Report: TAB Addendum
Function: Test, Adjust, & Balance
Date: 03/10/2026
Completed By: National TAB

PROJECT
03-02-26 CULVERS - MESA, AZ

Project: 03-02-26 CULVERS - MESA, AZ

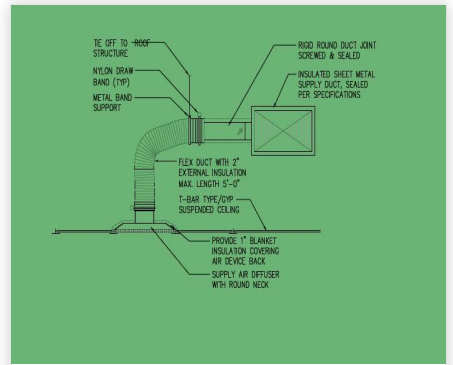
Issue Name : RIGID DUCT NOT INSTALLED
Description : MSET details cookline duct flex to come from a rigid straight pipe. Duct is flex only on some branches and is not straight. Recommend installing straight pipe from main supply drop and duct coming down straight, not curvy, so no smoke issues arise in kitchen and flow balances properly. UPDATE: FIXED, SHOWN IN 2ND PIC
